DEPARTMENT OF THE ARMY
UNITED STATES ARMY TANK - AUTOMOTIVE AND ARMAMENTS COMMAND
ARMAMENT AND CHEMICAL ACQUISITION AND LOGISTICS ACTIVITY
ROCK ISLAND, ILLINOIS 61299-7630

Attached you will find a proposed design modification for the U.S. Army M67 Mortar Sight Unit authorized under Nuclear Regulatory Commission (NRC) Registration Certificate Number NR-0155-D-126-S (Model M67 tritium illuminated mortar sight) and held under NRC License 12-00722-06.

SUBJECT: Proposed Design Modification to the M67 Mortar Sight Unit

Subject: Coarse Azimuth Scale (CAS) design change proposal

Fig. 3

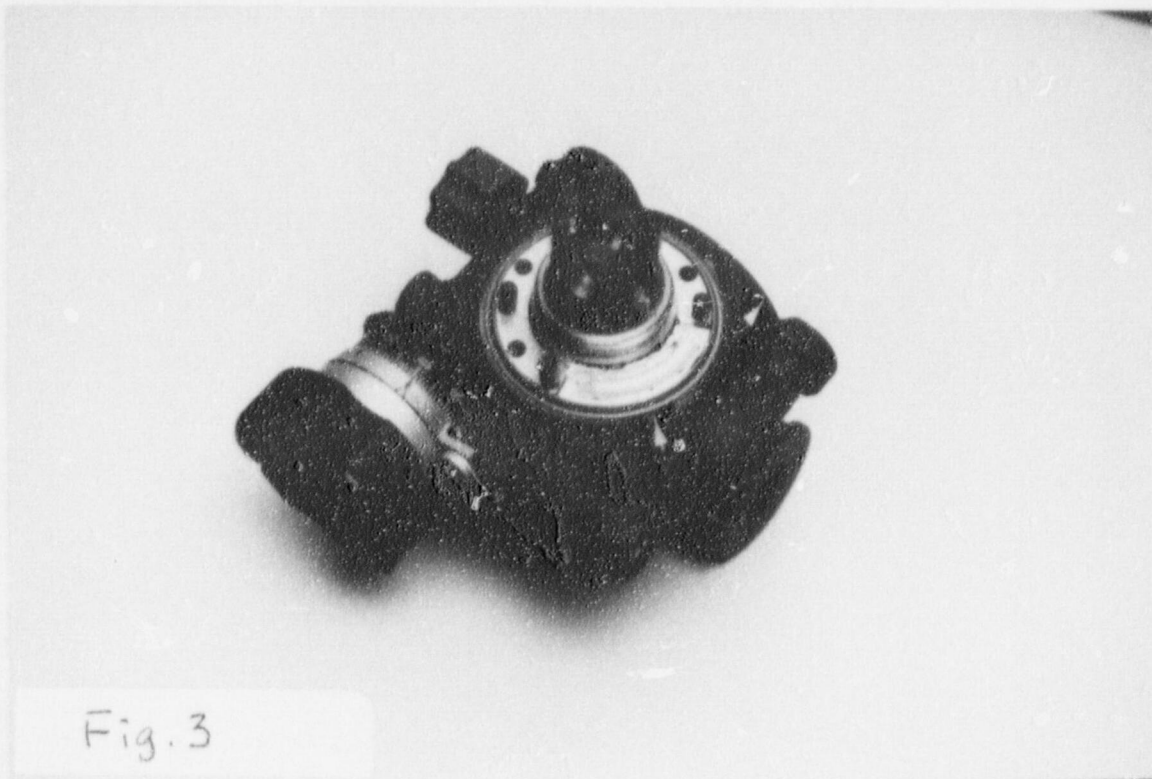
Fig. 1 shows the present layout of the tritium lamp assembly and plungers.
Fig. 2 shows the spacer ring on the retaining ring without the tritium lamp assembly.
Fig. 3 shows both a spacer ring and the tritium lamp assembly.
Fig. 4 shows the gap between the spacer ring and the tritium lamp assembly.
Fig. 5 show the spacer ring and the dowel pins (note: the spacer ring was sectioned into two pieces for alignment purpose.)

Fig. 4

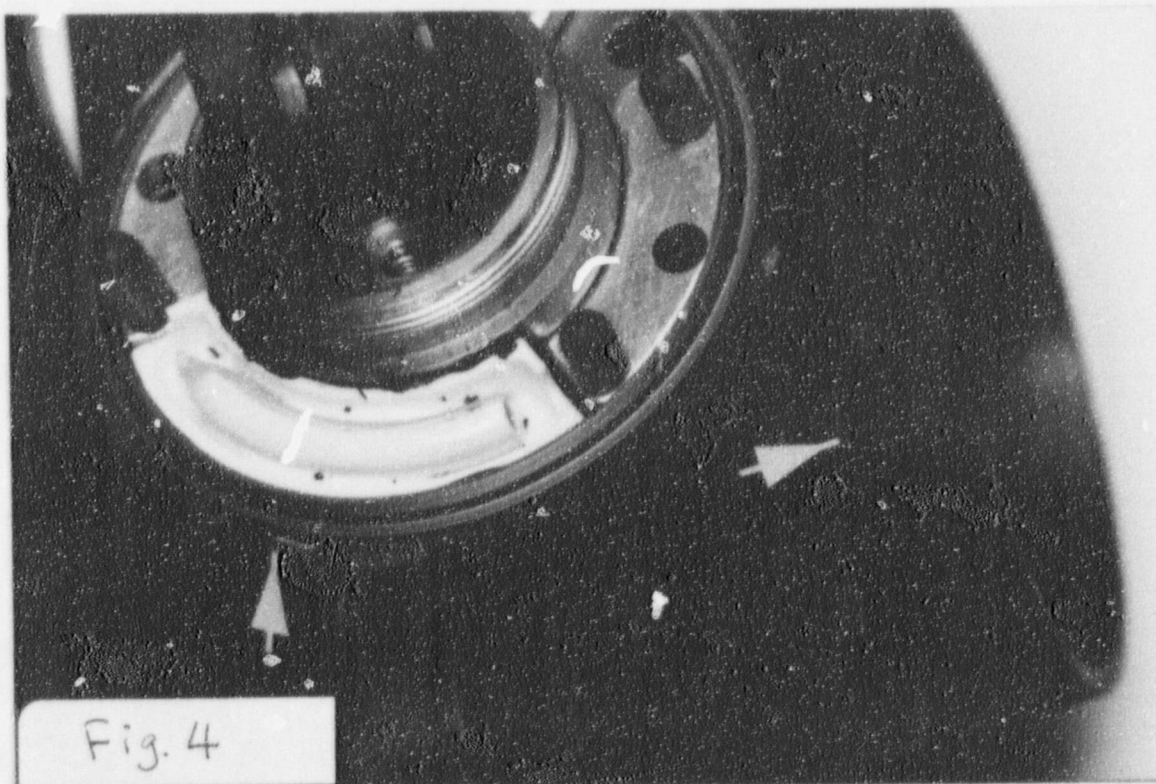
Temperature: The sight unit is required to operate at the temperature range of -30°C to 65°C . The thermal expansion of the spacer ring and the lamp assembly is estimated about 0.008 inches. Since there is a 0.030 inch opening between the spacer and the lamp assembly, they will not touch. No additional stress will be induced to the lamp assembly by the spacer.

Fig. 1

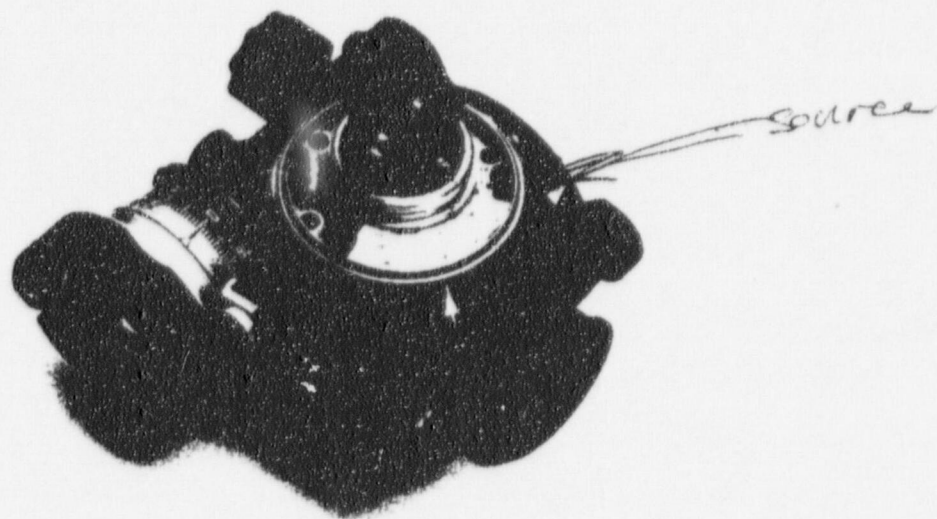
Fig. 1 shows the present layout of the tritium lamp assembly and plungers.
Fig. 2 shows the spacer ring on the retaining ring without the tritium lamp assembly.
Fig. 3 shows both a spacer ring and the tritium lamp assembly.
Fig. 4 shows the gap between the spacer ring and the tritium lamp assembly.
Fig. 5 show the spacer ring and the dowel pins (note: the spacer ring was sectioned into two pieces for alignment purpose.)

Fig. 4

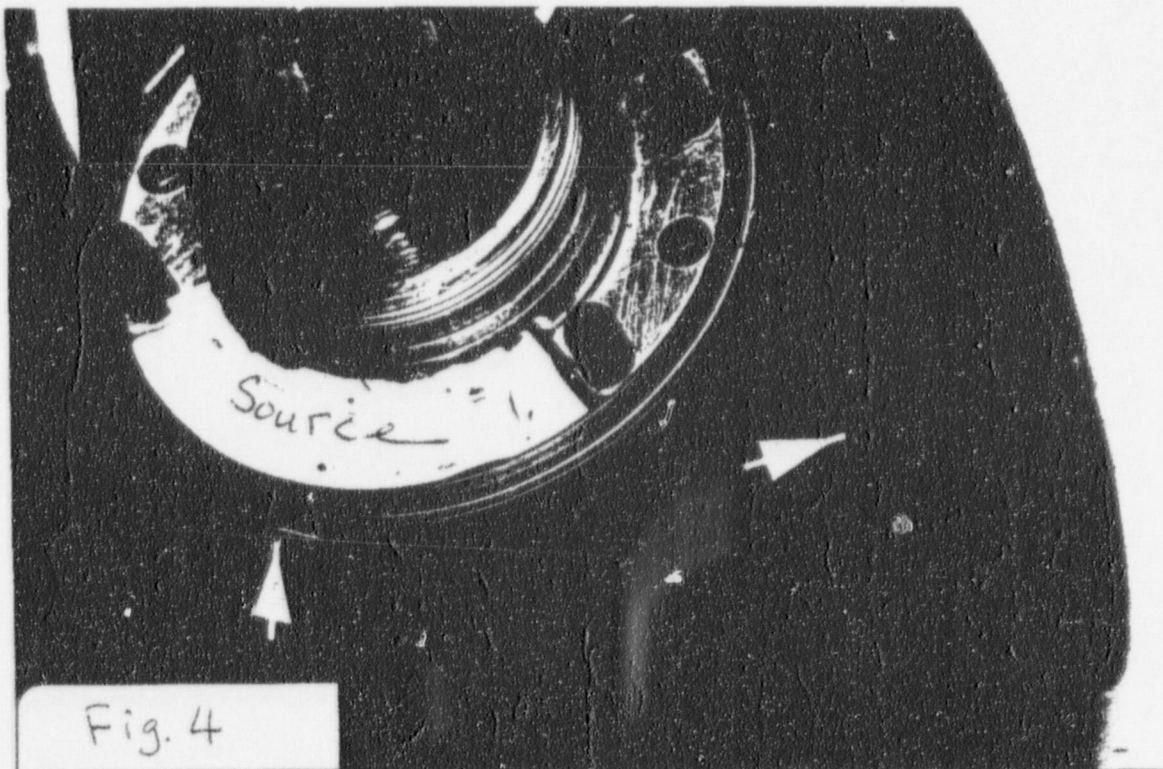
Temperature: The sight unit is required to operate at the temperature range of -30°C to 65°C . The thermal expansion of the spacer ring and the lamp assembly is estimated about 0.008 inches. Since there is a 0.030 inch opening between the spacer and the lamp assembly, they will not touch. No additional stress will be induced to the lamp assembly by the spacer.

Fig. 5

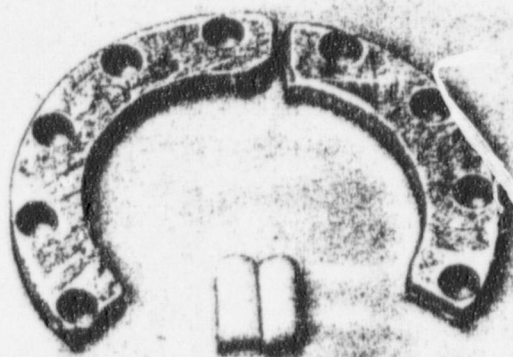
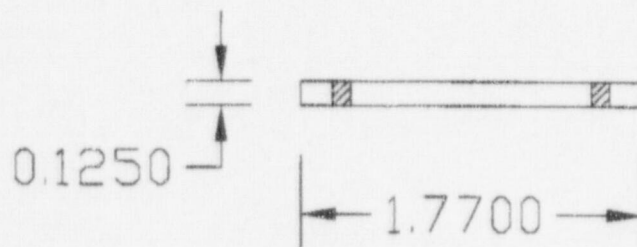
Vibration: Once the spacer is installed, it will be secured with a dowel pin and sealing compound and become stationary. In accordance with ANSI N540, frequency of 10 Hz to 55 Hz is used for the vibration test. Since the majority of the sight unit is made out of steel, the stiffness is estimated about 1×10^6 lb/in. With the addition of the spacer, the natural frequency of the sight unit is estimated about 1717 Hz. This value should not be any cause for concern to the stability of the tritium lamp.
